Dear Landmarks Commissioners,

We live at 202 N Spooner St, on the same block as the proposed new lot, but **not** adjacent to it. We believe that two of the three criteria in Landmarks's mandate 41.18(4) are violated by the proposal. For these and other reasons below we respectfully oppose the proposal.

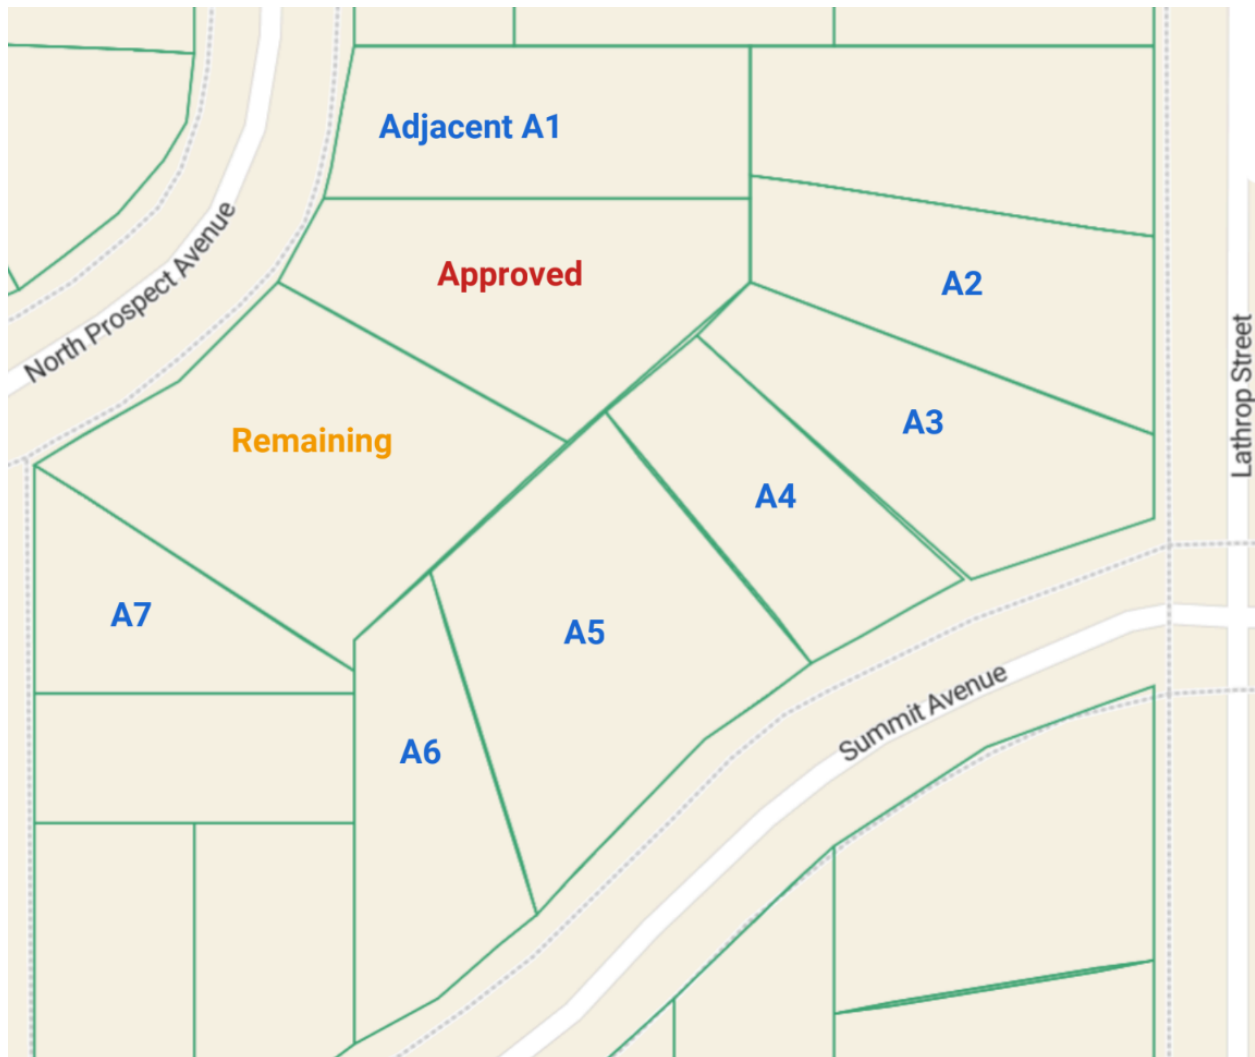
One doesn't necessarily even need numbers. Here's a visual³ showing how anomalous the proposed new lot size is compared to the adjacent lots:

The proposed new lot is significantly smaller than every adjacent lot. This fact alone suffices to reject the proposal.

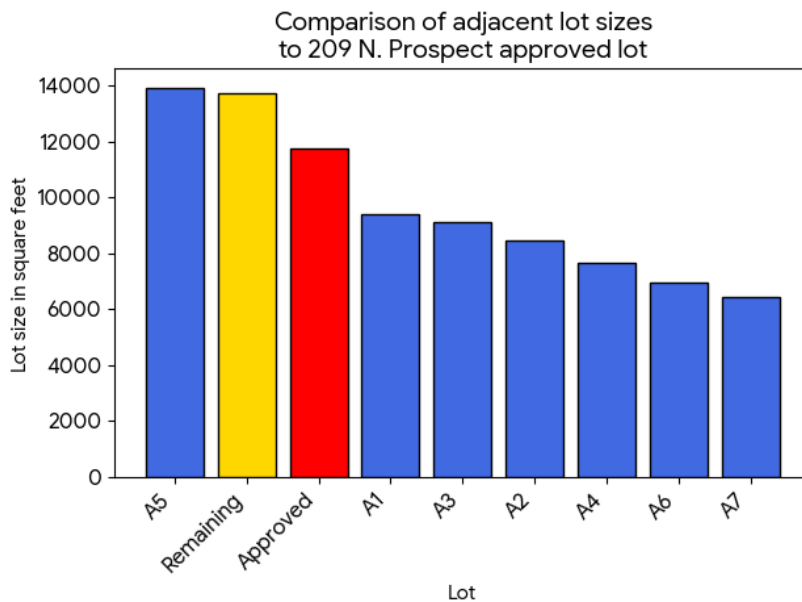
Furthermore, here is a visual⁴ of a lot subdivision that was approved, at 209 N Prospect Ave. in the next block east of the subject block:

Again, one doesn't need the numbers to notice that the approved lot size isn't "not compatible." Indeed, rather than being substantially smaller than every **adjacent** lot (like the applicant's proposed lot would be); it is actually larger than most of them. Nevertheless, for completeness, here are the numbers⁵:

Plot View: CSM 1

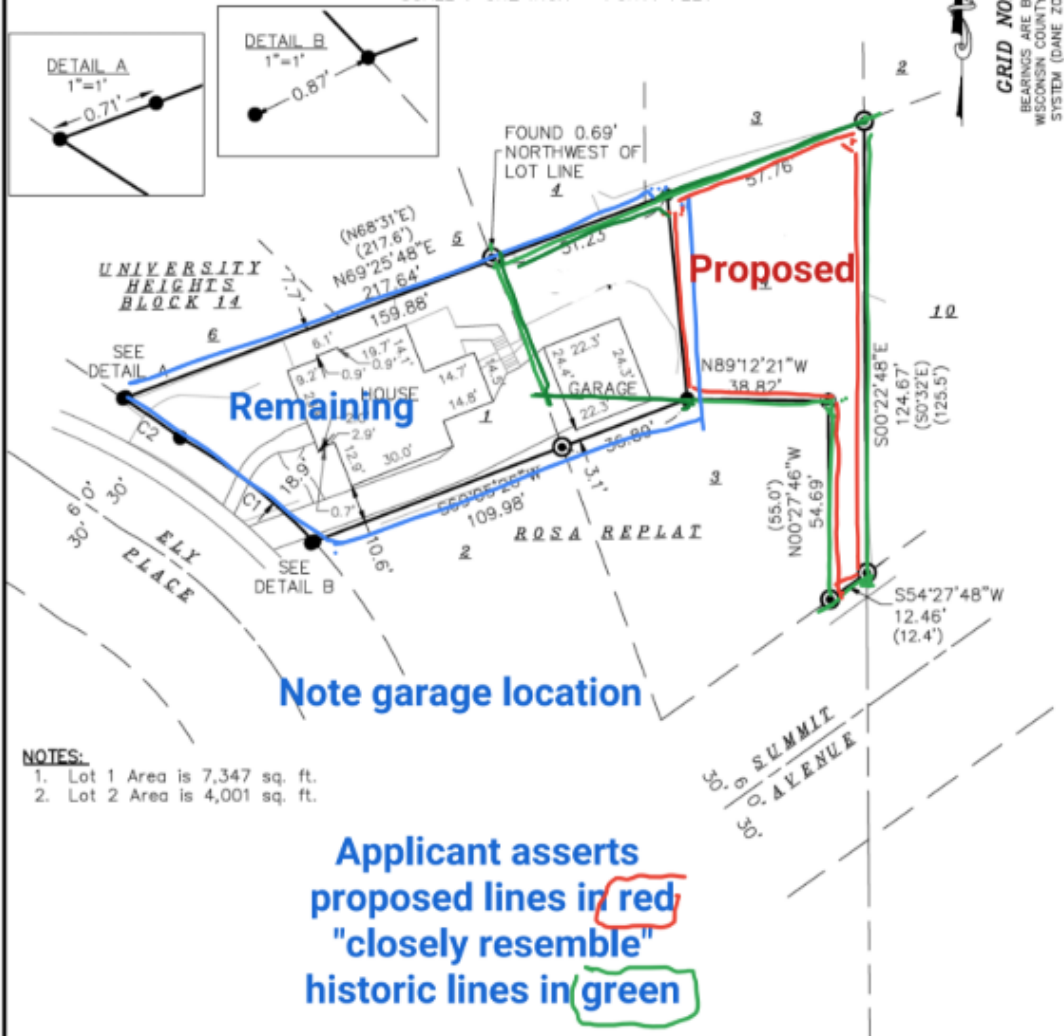
(3) The applicant cites a "close resemblance" to historic 1924 and 1950 plat lines. This is either disingenuous or a blatant untruth, unless the submitted diagrams of those historic lines are erroneous. Note that the applicant's current garage falls on the wrong side of the **historic** line. In other words, if the applicant wanted to truly honor that historic line, his garage and house would be on separate lots. The following visual shows that the applicant's "close resemblance" is bogus:
